SUBJECT: INDEPENDENT QUALITY REVIEW GROUP COMMENTS ON THE ABB-COMBUSTION  
ENGINEERING (ABB-CE) SYSTEM 80+ CERTIFIED DESIGN MATERIAL (CDM) AND  
ABB-CE STANDARD SAFETY ANALYSIS REPORT (CESSAR-DC)

An Independent Quality Review Group has reviewed the CDM and the CESSAR-DC, and provided their comments to the staff inspections, tests, analyses, and acceptance criteria (ITAAC) task groups. The ITAAC task groups have reviewed the comments, and those that require action by ABB-CE are contained in the enclosure.

FIGURE 2.5.1-2  
PLANT PROTECTION SYSTEM INTERCONNECTIONS

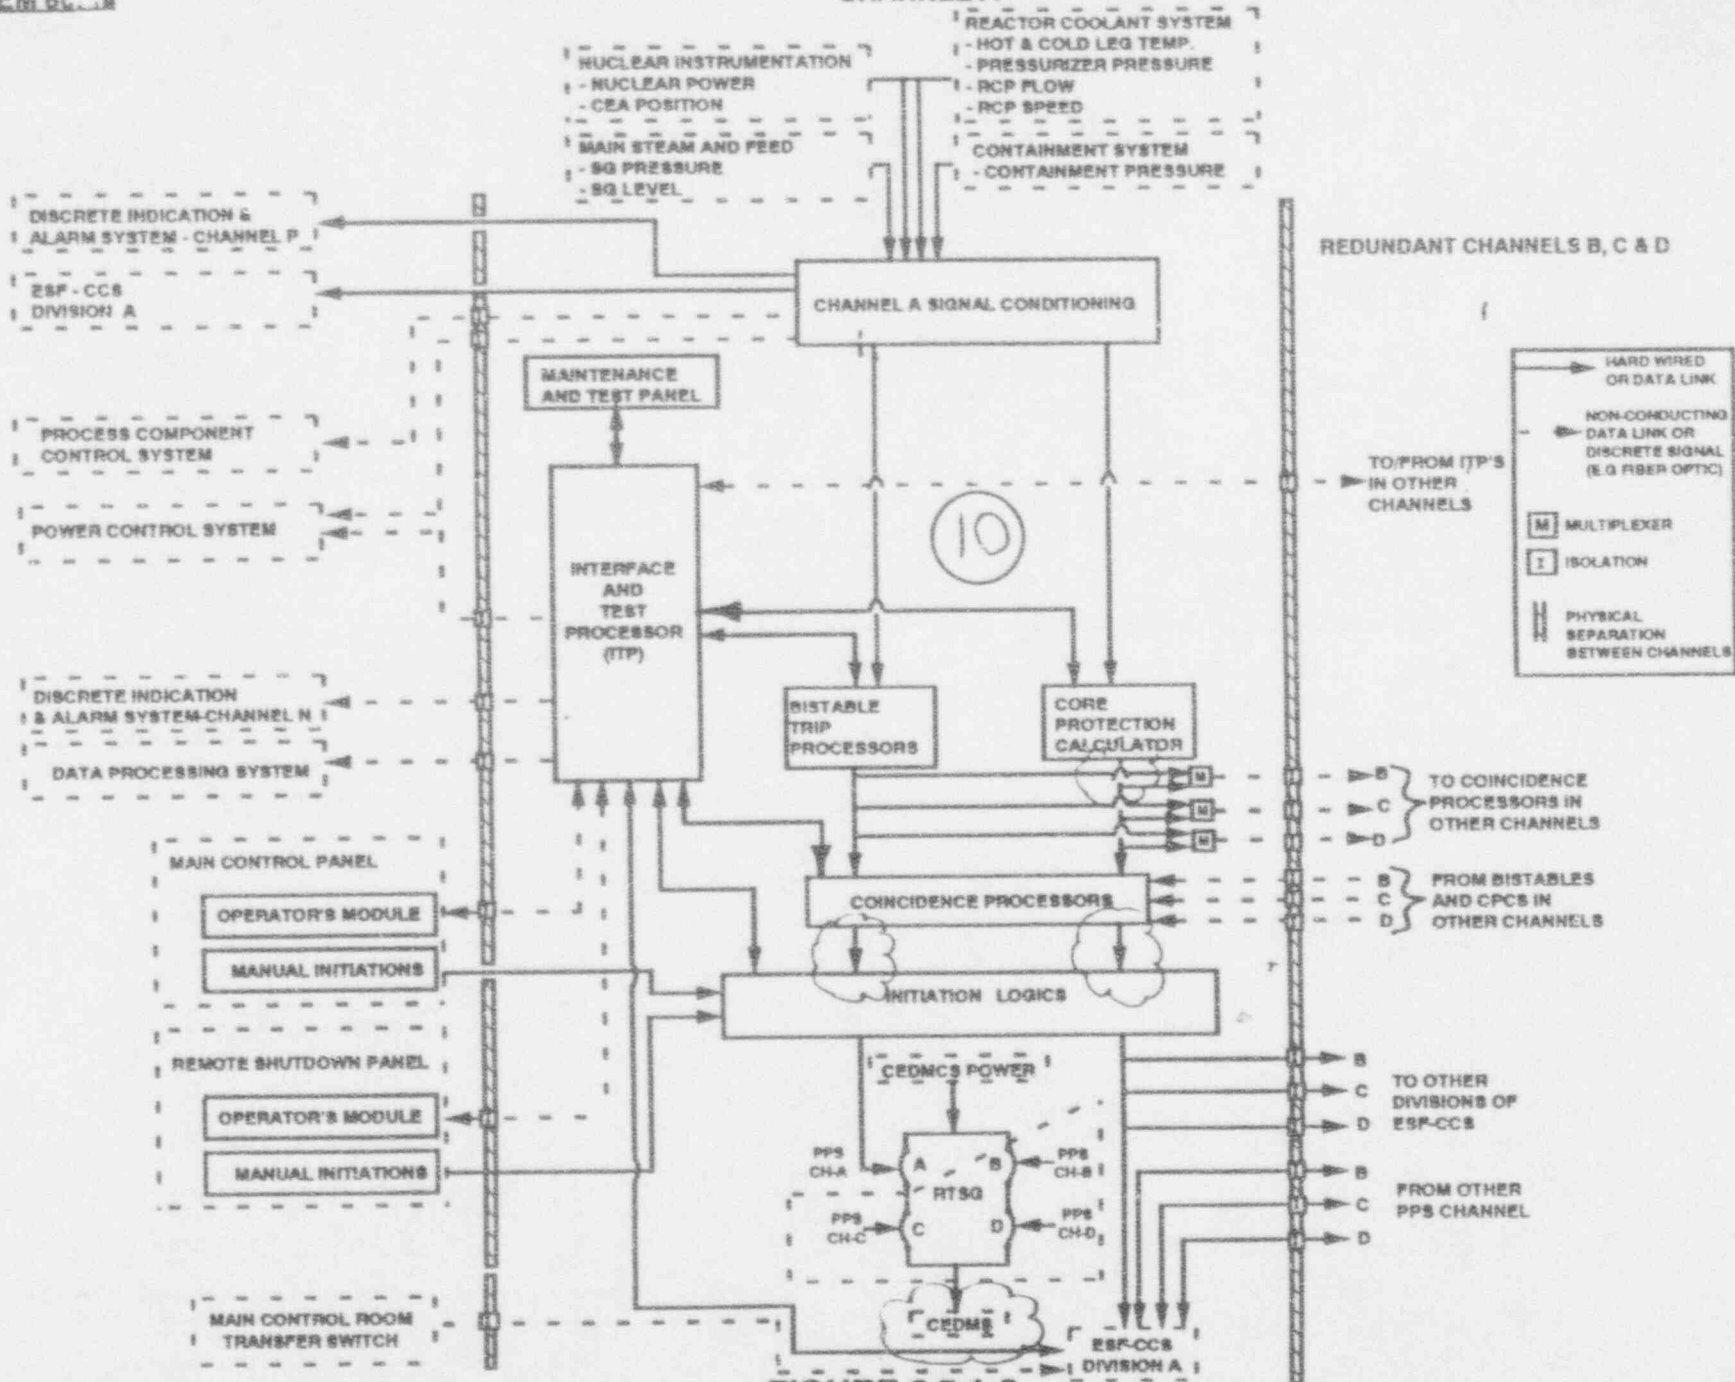
No.	Comments	Cat.	Resolution
1	Figure 2.5.1-2, "PPS Interconnection" does not clearly specify 2 coincidence/bistable processors per channel. See 2.5.1, Pg 1 (attached).	1	AGREE - PASS TO AFFILIATE
2	Page 1 of design description states that the Interface and Test processor communicates with the bistable trip processors and coincidence processors. Figure 2.5.1-2 indicates that the ITP communicates with the Core protection calculator, control room and remote shutdown panels, ESF-CS, maintenance and test panel and the initiation logics. The design description should be clarified. See Figure 2.5.1-2 (attached).	1	
3	Page 2 of CDM states that EMI qualification is applied to equipment with known EMI susceptibility based on operating environment and/or inherent design characteristics. How is "known susceptibility" to be determined? Suggest revising statement to: EMI qualification is applied for equipment based on the operating environment and/or inherent design characteristics. See also CE SSAR 7.2.1.2 Design Bases (attached).	1

10	Figure 2.5.1-2. The figure indicates that communication between the CPC and the ITP and ITP to coincidence processors is in only one direction. Is this correct? Core protection calculator output is unclear (drafting error). The coincidence processors (Figure 2.5.1-2) indicate two output paths. What is the distinction between the two? (it appears that the initiation logic block should be split to represent ESF logic in the figure and be consistent with Figure 2.5.1-3. In Figure 2.5.1.-1 the RTSG is shown feeding the CEDMCS. Figure 2.5.1-2 states CEDMS. The design description references the CEDM system (see Page 5, last paragraph)? System notations are not consistent. (see attached)	1	
11	CE SSAR 7.1.2.2. Page 7.1-2 lists Reactor Trip switchgear System (RTSS) the CDM lists Reactor Trip Switchgear (RTSG). See 2.5.1, Page 6, first paragraph. (attached-see 9 above) These should be made consistent.	1

FIGURE 2.7.6-1  
COMPONENT COOLING WATER SYSTEM  
(ONE OF TWO DIVISIONS)

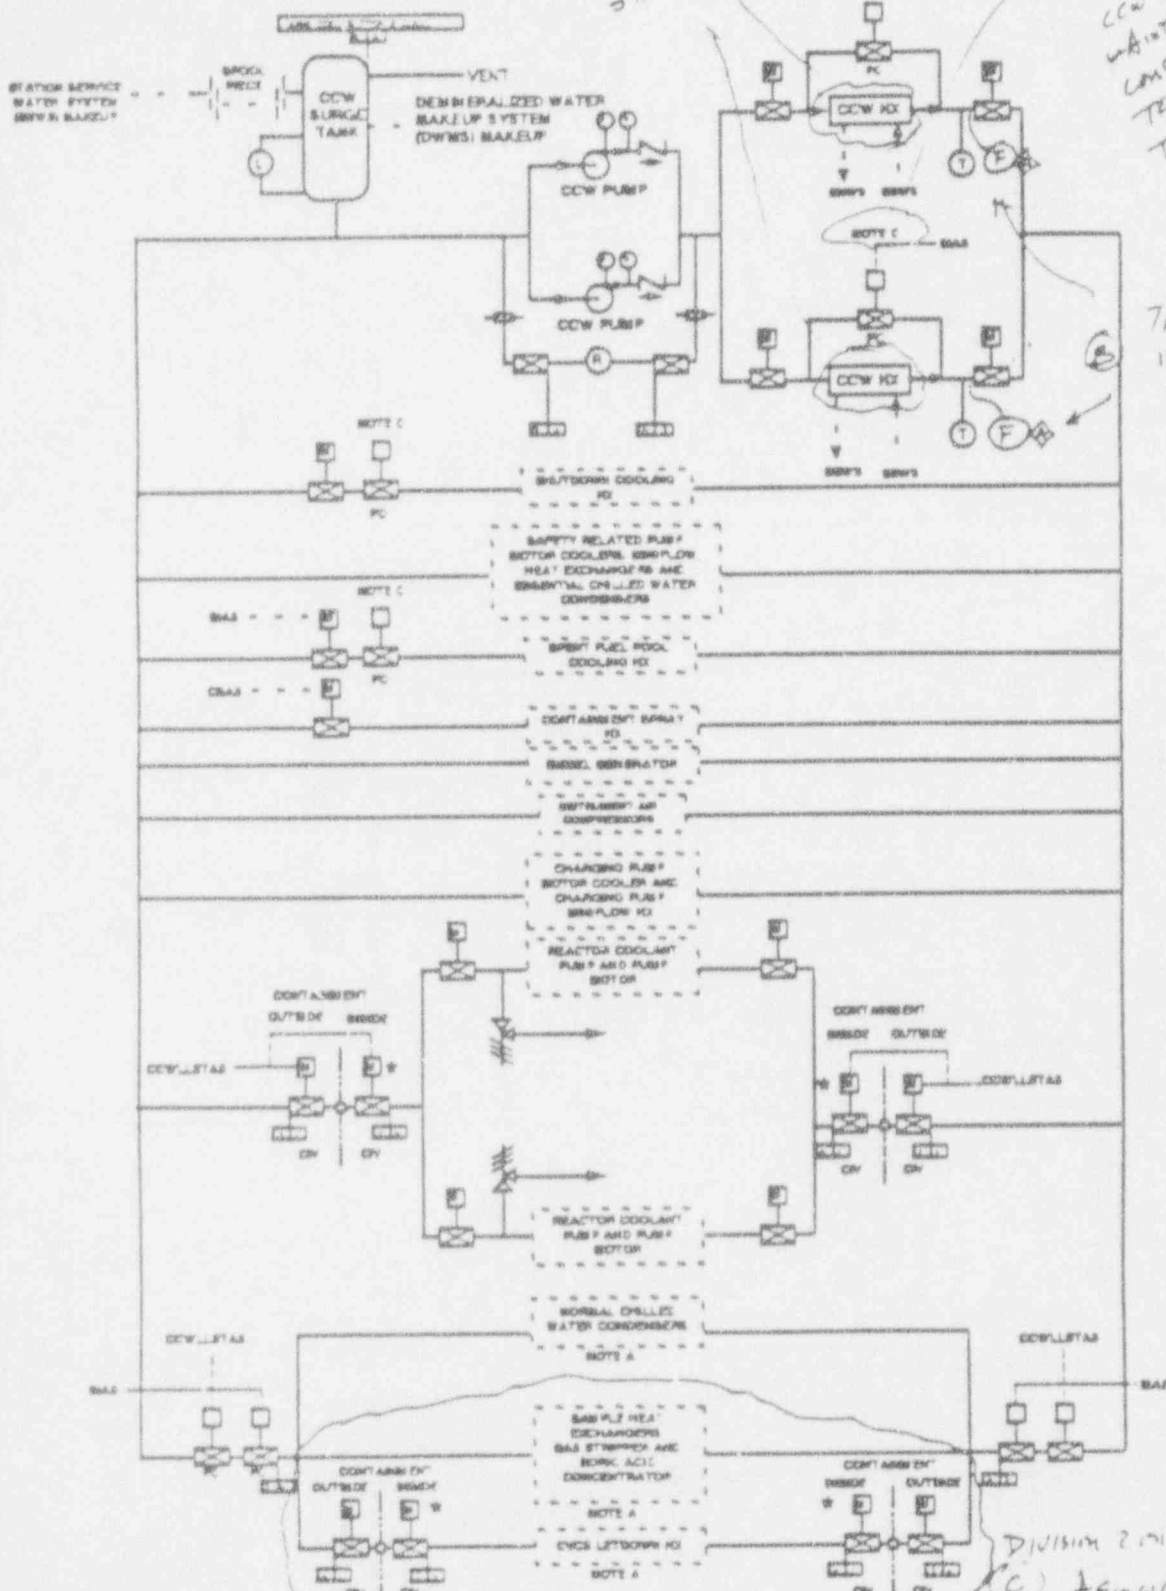
CCW HX ARE SMALL TAG & HELL-TYPE TYPE WITH ICE CCW FLOW ON THE SHELL SIDE.

THESE "HOT" ARE IN CONTACT. THESE VALUES WOULD MAINTAIN A RELATIVE CONSTANT CCW OUTLET TEMPERATURE. THEY ARE TEMPERATURE CONTROL VALVES.

FIGURE 2.7.8-1  
CONDENSATE STORAGE SYSTEM

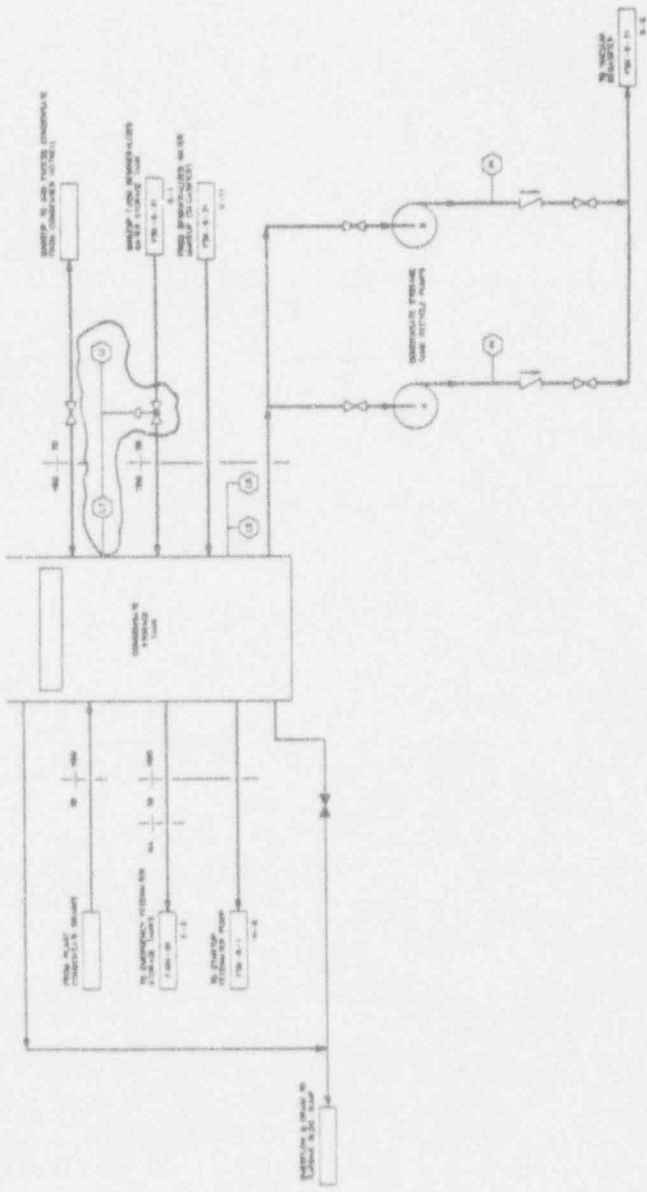
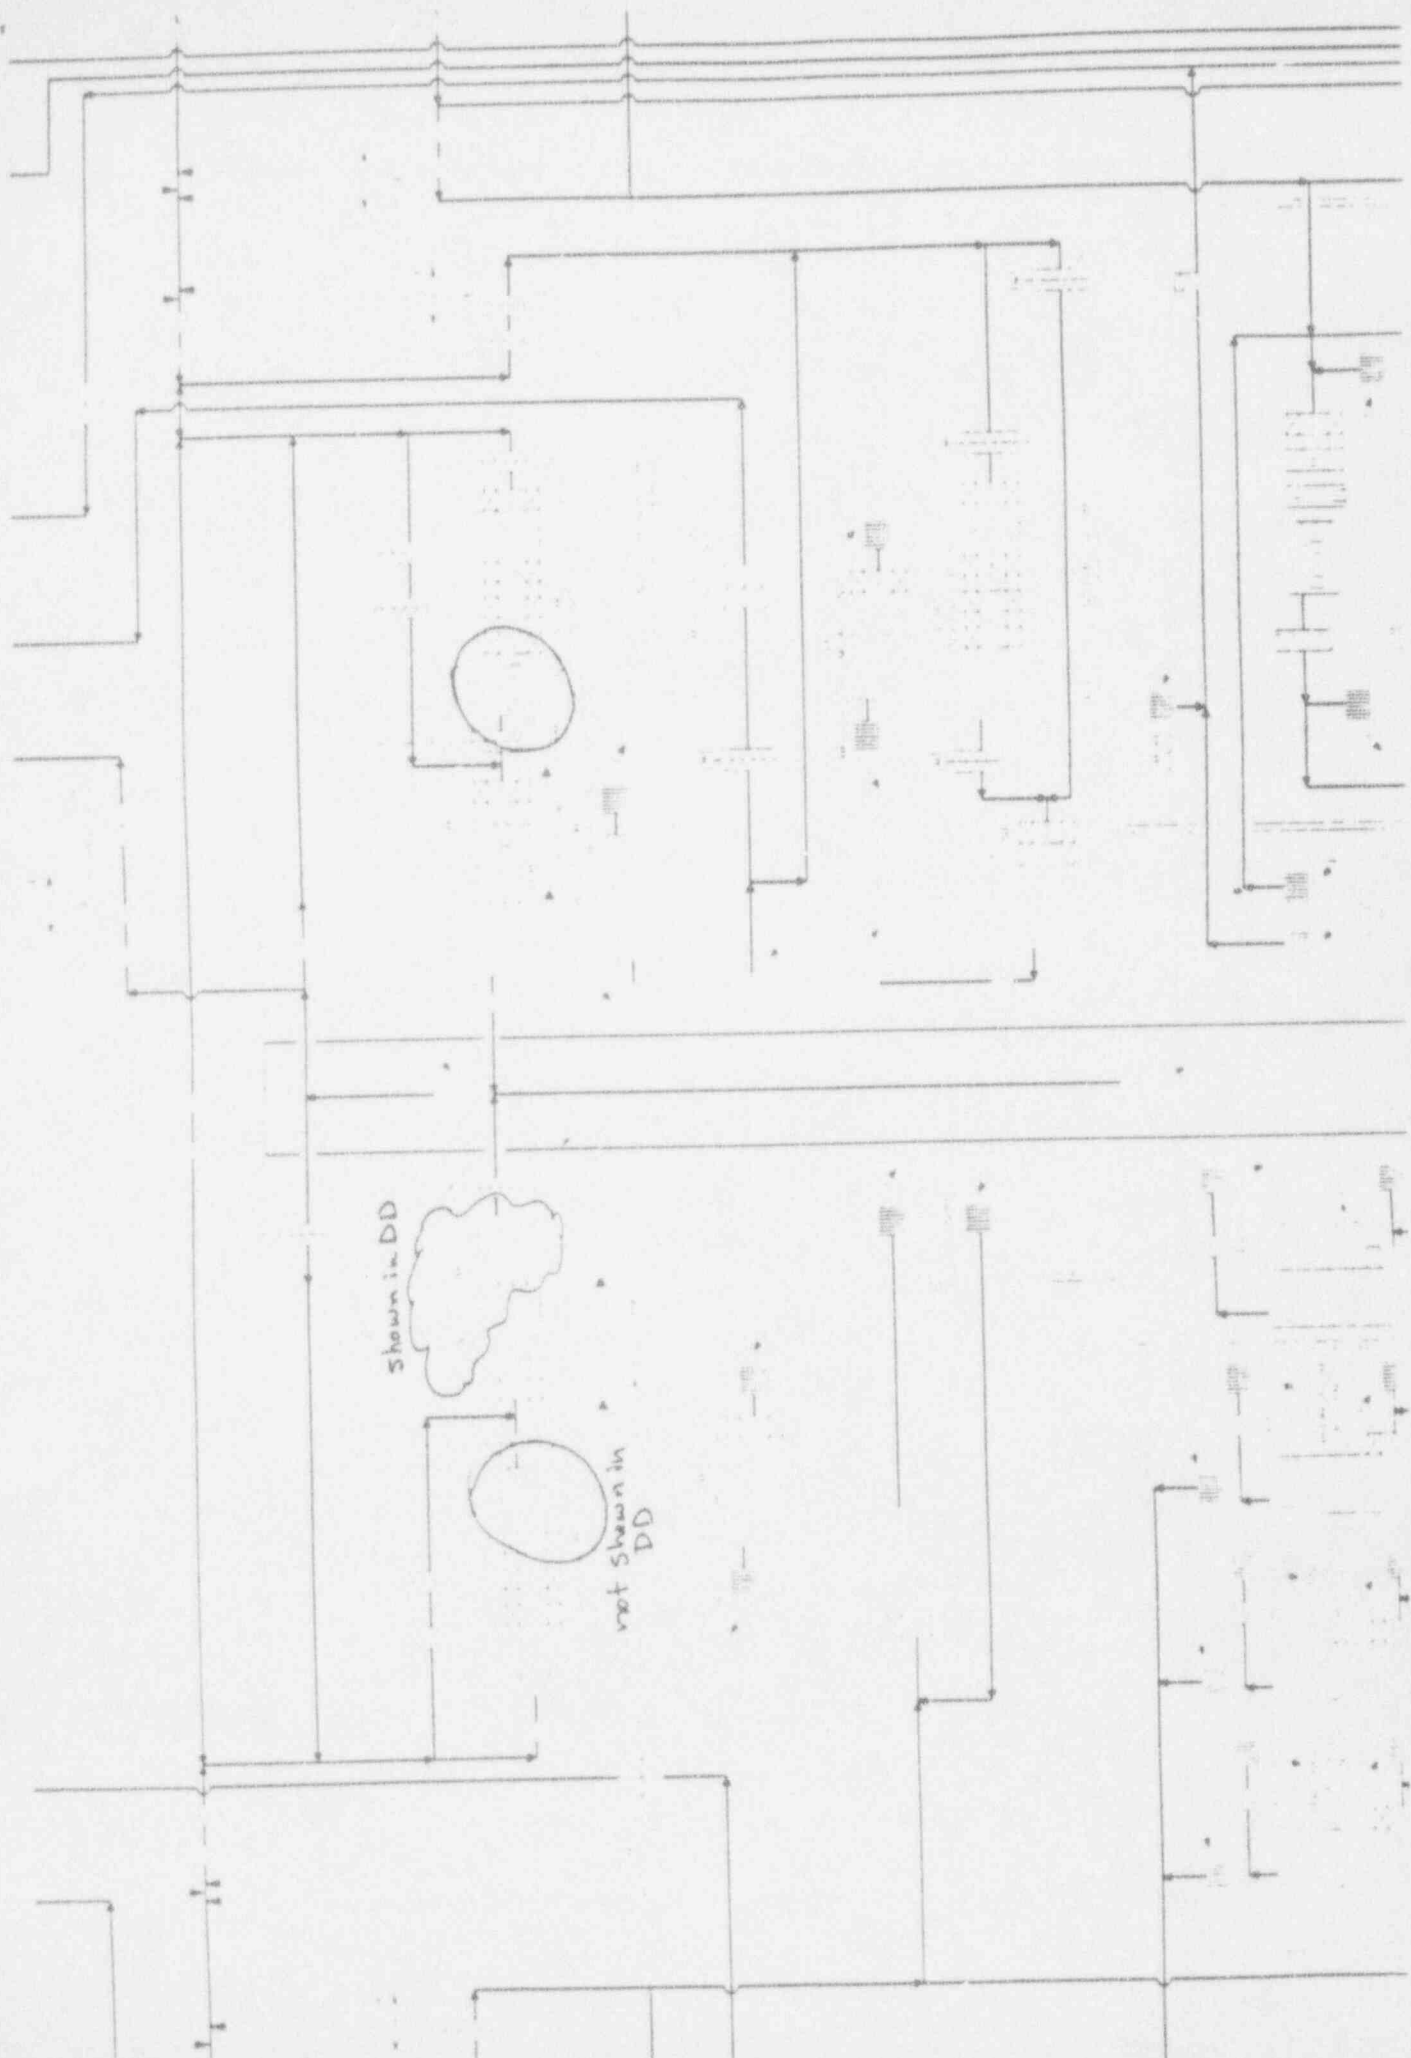
No.	Comments	Cat.	Resolution
1	Figure 2.7.8-1 showed a gate valve with an unspecified operator. CESSAR Figure 9.2.6-1 showed a diaphragm operated globe valve controlling the tank level from signals generated by a level transmitter. Please resolve this discrepancy.	1	Agreed - Refer to P&ID-11F

FIGURE 2.7.13-1  
 NORMAL CHILLED WATER SYSTEM  
 (ONE OF TWO DIVISIONS)

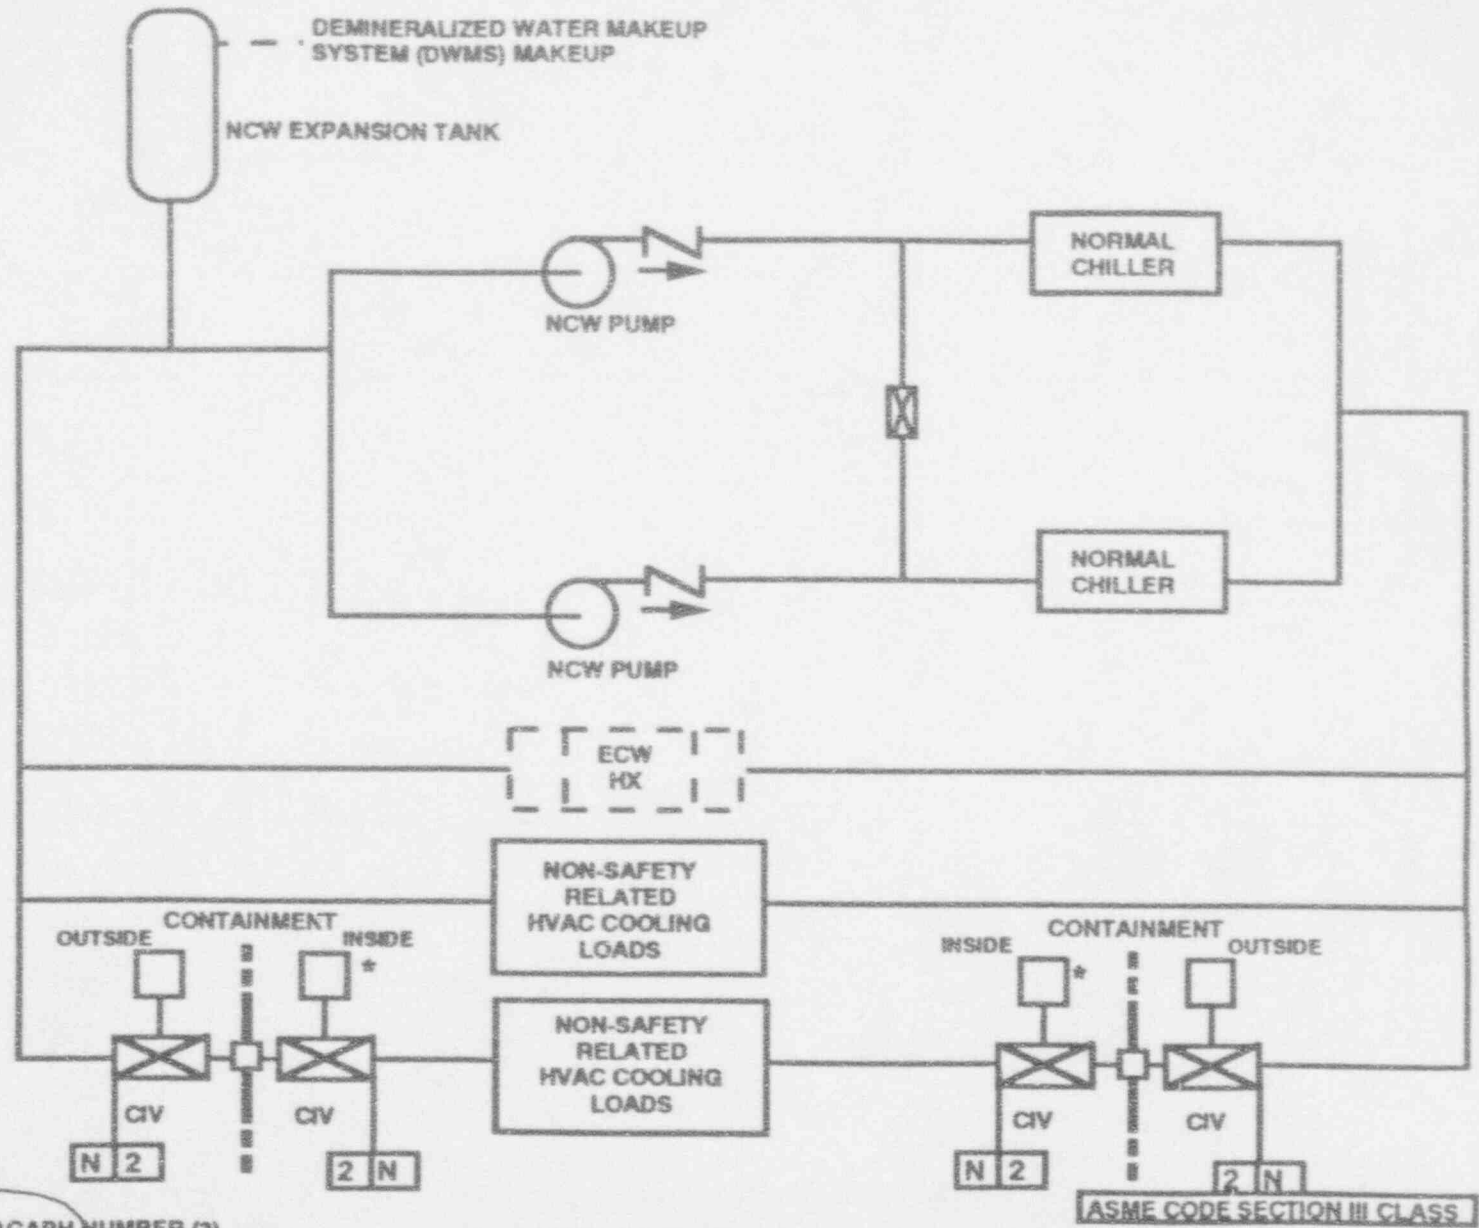
No.	Comments	Cat.	Resolution
1	See attached mark-up.	3	Agree - Pass to NBIS-CE

*Spelling*
